PLAN COMMISSION

OFFICIAL NOTICE & AGENDA

SUBJECT: General Development and Precise Implementation Plan Review

REQUEST: General Development Plan (GDP) and Precise Implementation Plan (PIP) approval for a new Discount Tire facility.

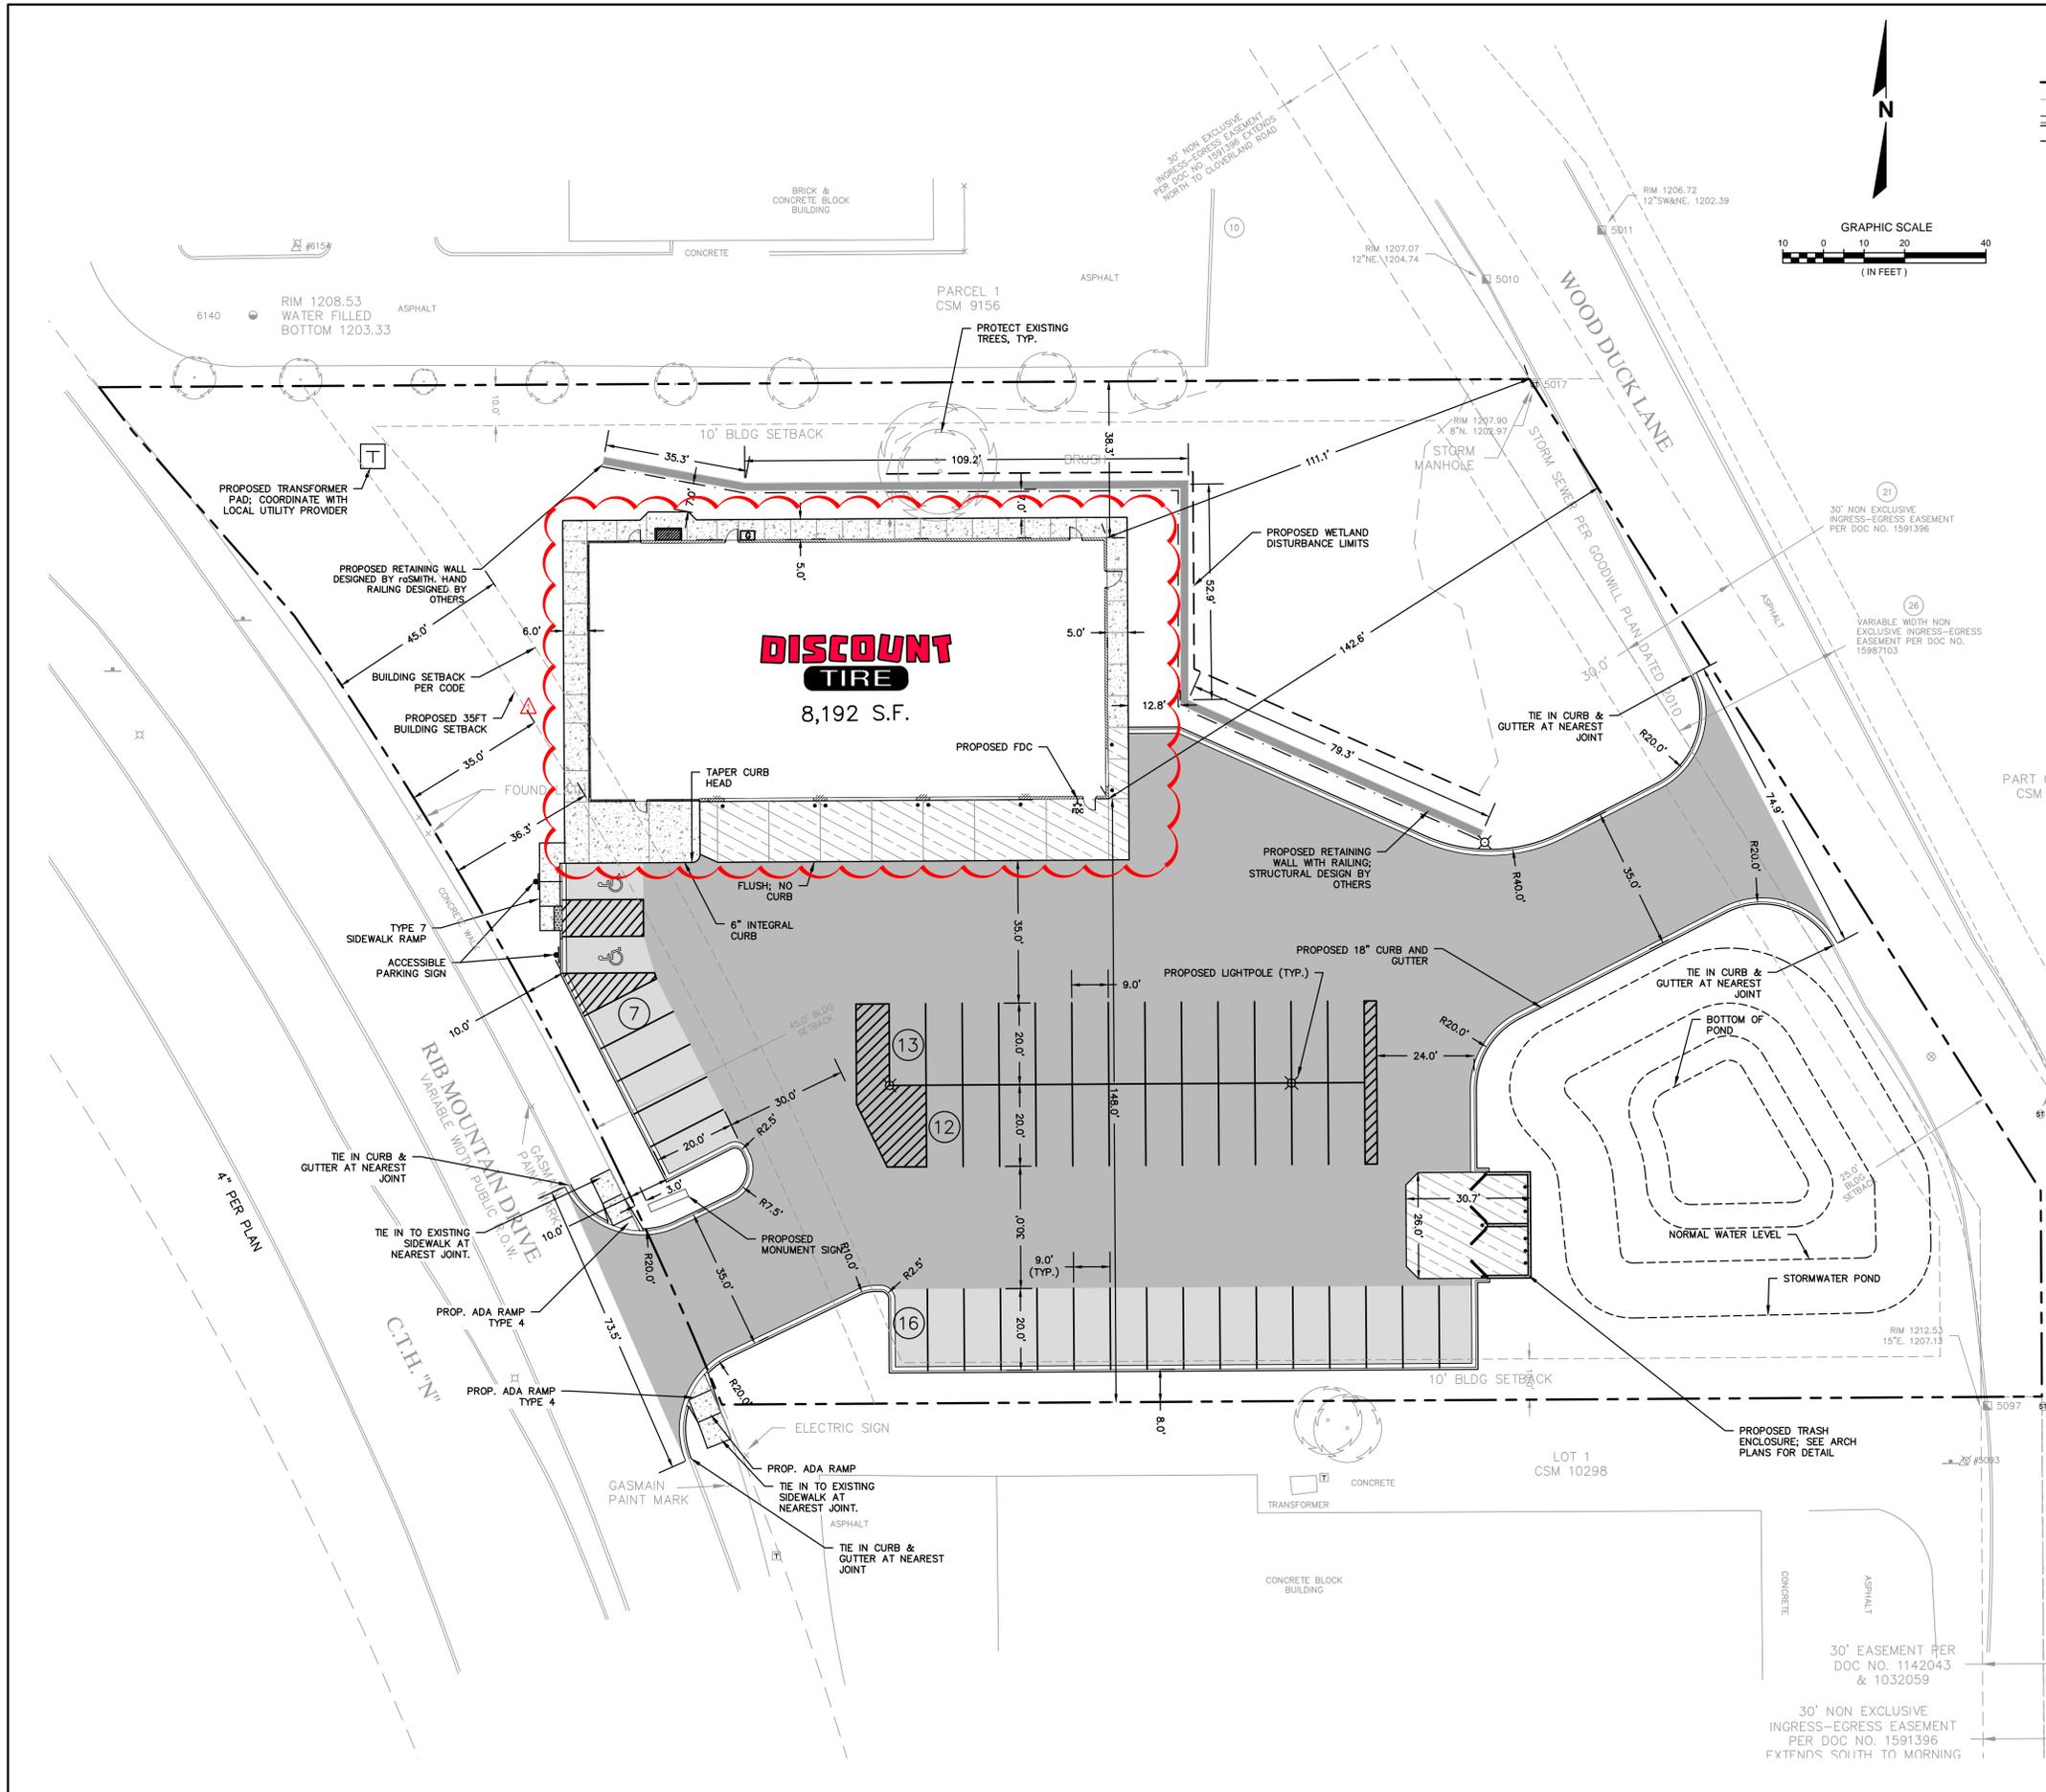
As such, the revised submittal requests moving the building 10 feet to the west. Due to the right-of-way along this stretch of Rib Mountain Drive being greater than 100 feet, the zoning ordinance typically requires a 45-foot setback (proposed to be 35 for the southwest corner of the building). The revised plan also includes a reduction in overall impervious area of approximately 3,000 square feet. The subject property does contain delineated wetlands proposed to be disturbed as part of the development. The applicant received a letter from the Wisconsin Department of Natural Resources approving the disturbance.

- Front yard setback: The proposal calls for a front yard setback of 35 feet, which is typical in most instances within Town. However, the right-of-way along this stretch of Rib Mountain Drive is greater than 100 feet, which requires an additional 10 feet in setback (45 feet).
- Signage: The proposed sign plan exceeds typical code maximums for both overall sign area and number of wall signs. The attached sign plan does not include a detail for the monument sign identified in the site plan; however, previous correspondence with the applicant indicated a 50 square foot sign.
 - **Typical Permitted Sign Area: 150 ft²**
 - Proposed Sign Area: 244 ft²
 - **Typical Permitted Wall Sign: 2**
 - Proposed Wall Signs: 3
